Sandon Point Flood Study

Addendum No. 1

106062-03 Report 002 rev 2

Prepared for Stockland Development Pty Ltd

LEGEND

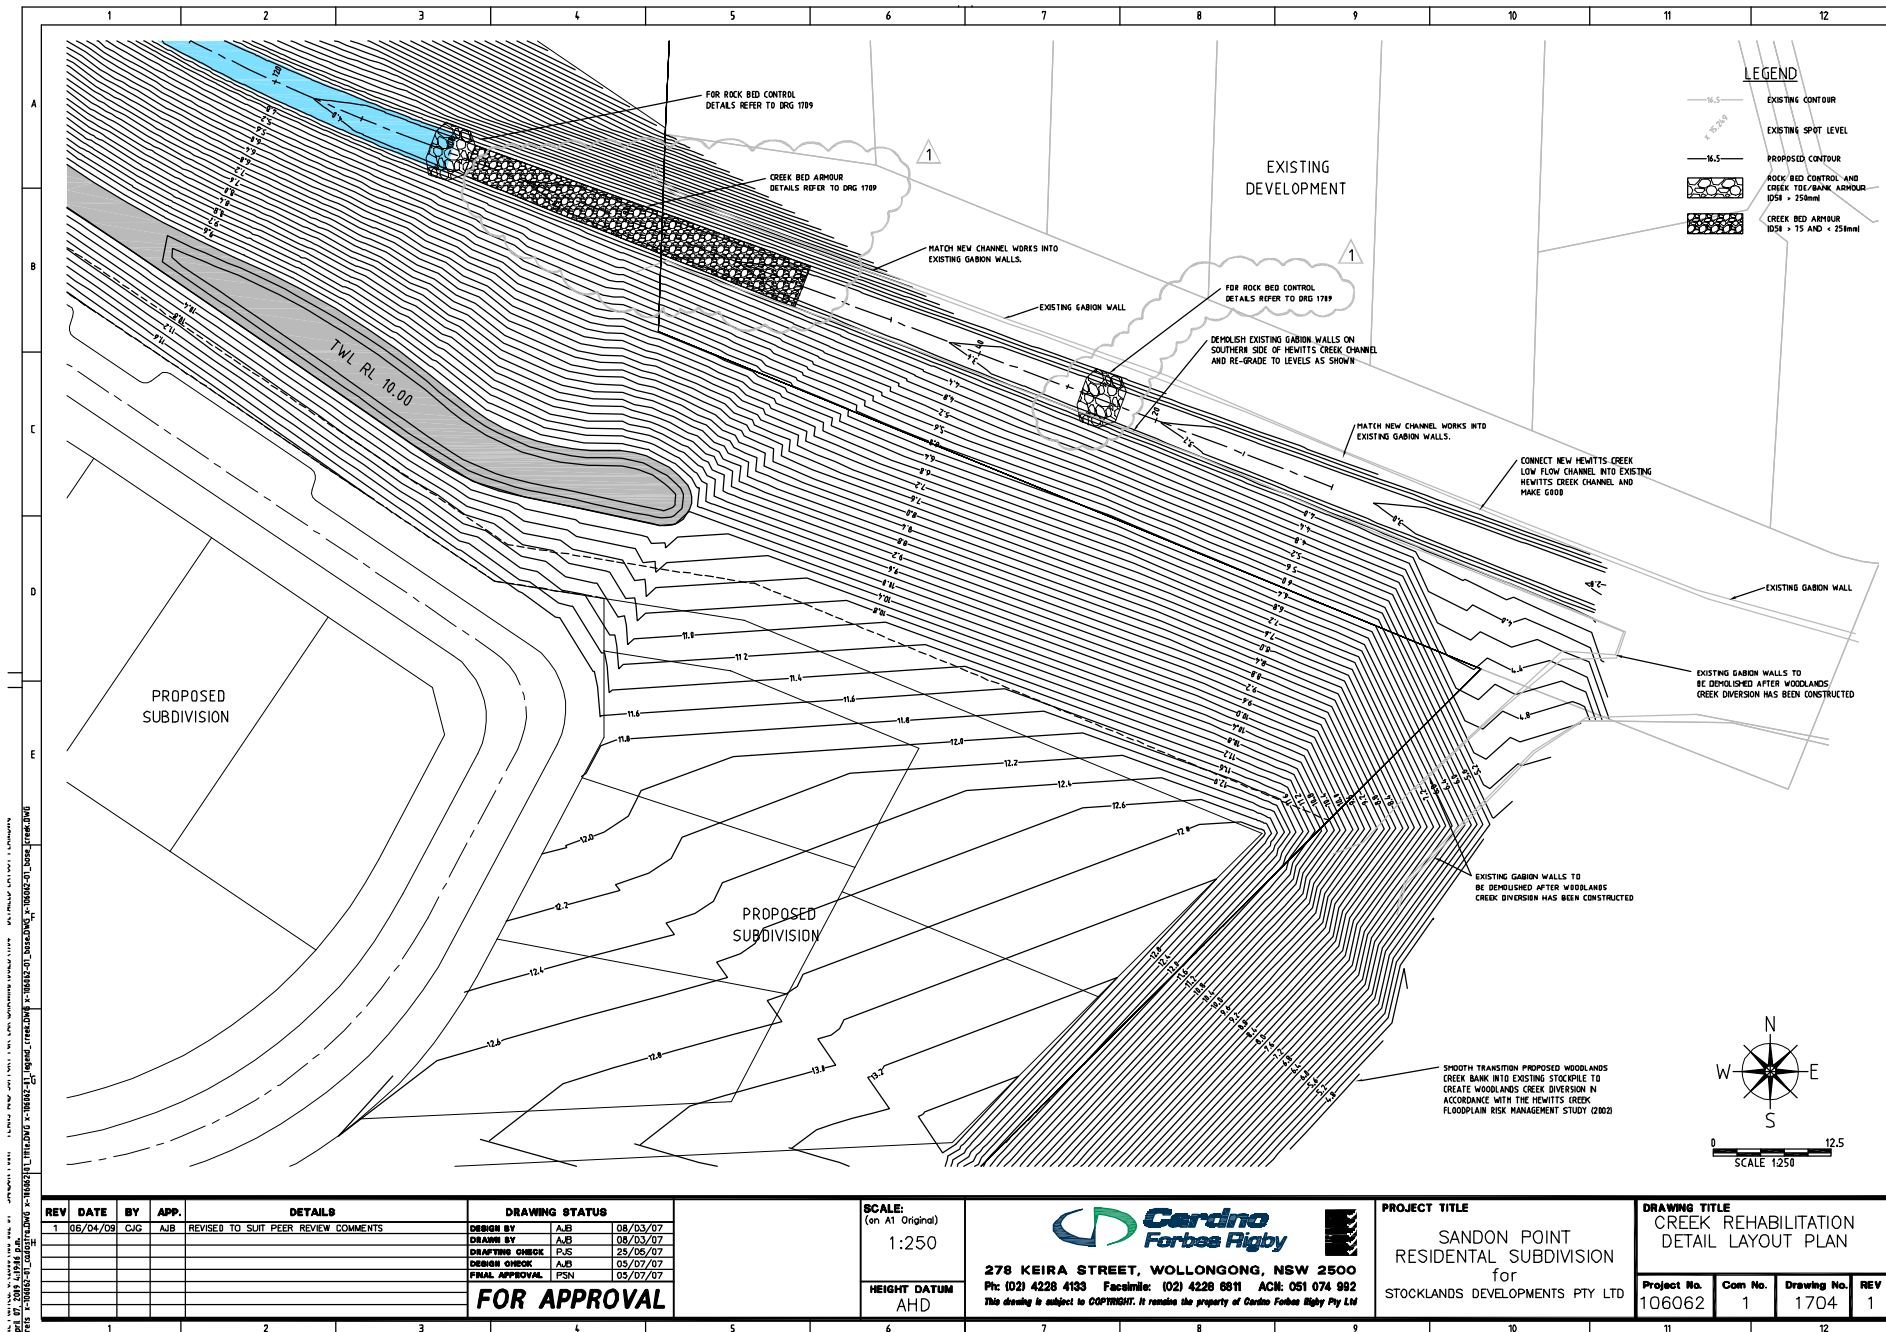
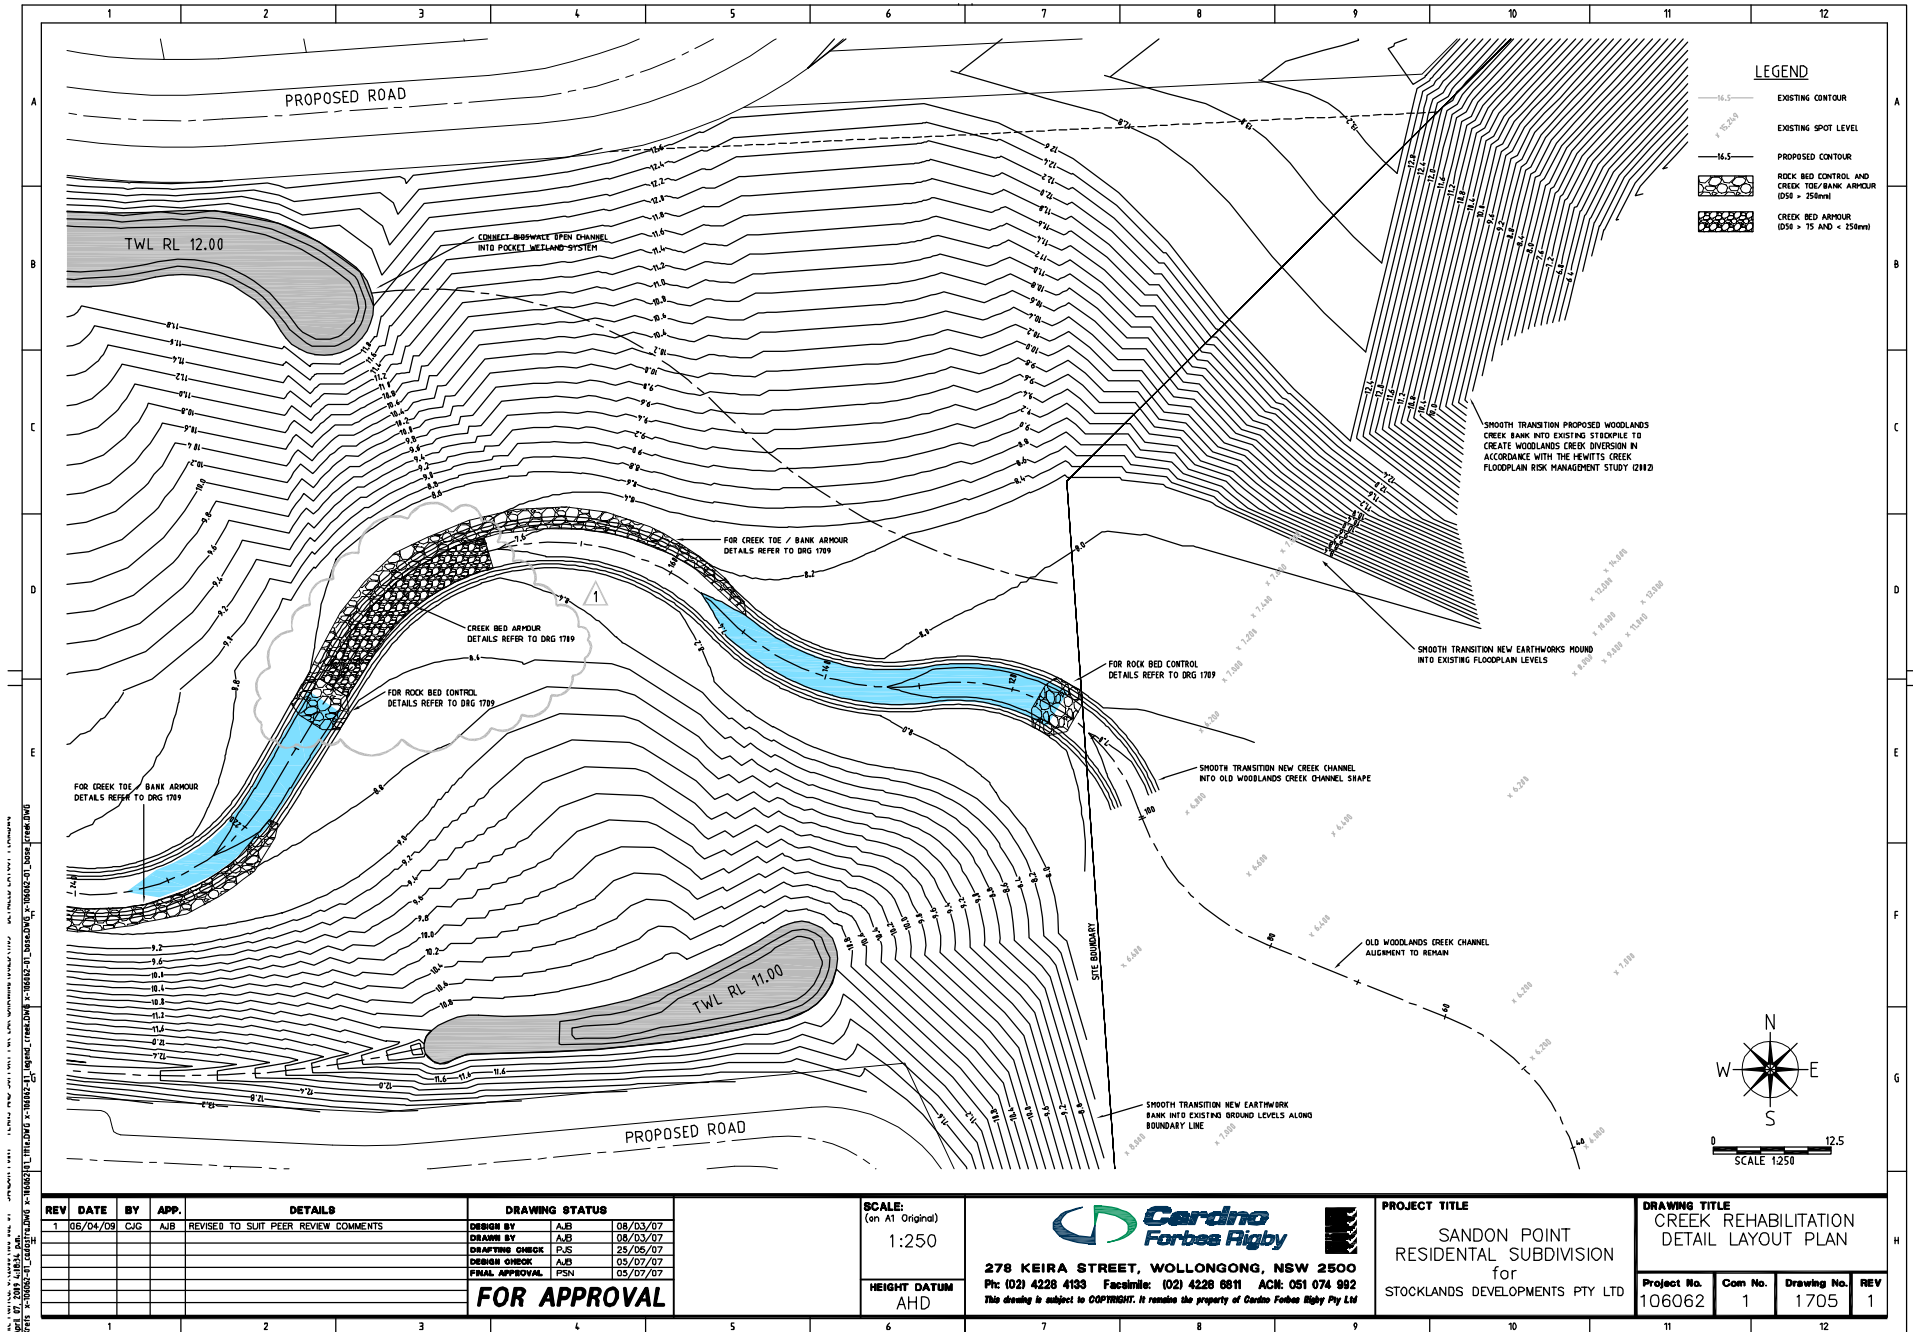
Sizing of rocks in the erosion protection treatments is potentially undersized, considering the estimated shear stresses and velocities, and the shear stress and velocity thresholds presented in Fischenich (2001), on which Cardno's rock armour sizing is based. While the general nature of the treatments are acceptable, the size of the rocks which make up the treatment may need to be increased to provide sufficient stability (given the Director-General's requirements for a 20 year ARI design event). Therefore, it is recommended that Cardno reconsider the required sizing of the rocks in the erosion protection treatments.

CFR has amended the design plans to show a general increase in the application of rock to the creek bed, to cater for SKM's concerns regarding a potential under sizing of this material. The updated design plans are included in this report as **Appendix B**. CFR will further consider such changes to the rock armouring details at detailed design stage. We consider no further action is required.
